WARRANTY INFORMATION LETTER

No. WI25-014
Release 09/15/2025
Effective 07/31/2025
Subject Power Steering Tank Venting Diagnostic Procedures Revision

Examples of misting on tank from the T/S guide.

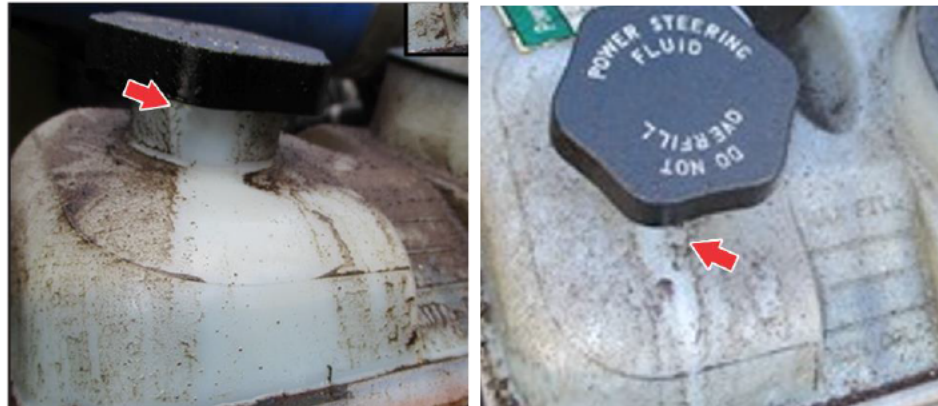
As of July 31, 2025, revisions to the CEEA-CEEA+ Troubleshooting Guide, 5.12.4 Power Steering Tank Venting Diagnostics procedures have clarified diagnostic criteria for power steering tank concerns. These updates specify that oil misting on the tank's exterior is considered a normal condition caused by venting. The updated procedures also provide improved guidelines on cap-related failures.

New Guidelines:

| Condition | Procedure |
| Misting | Normal condition, clean tank |
| Broken/missing cap | Replace cap |
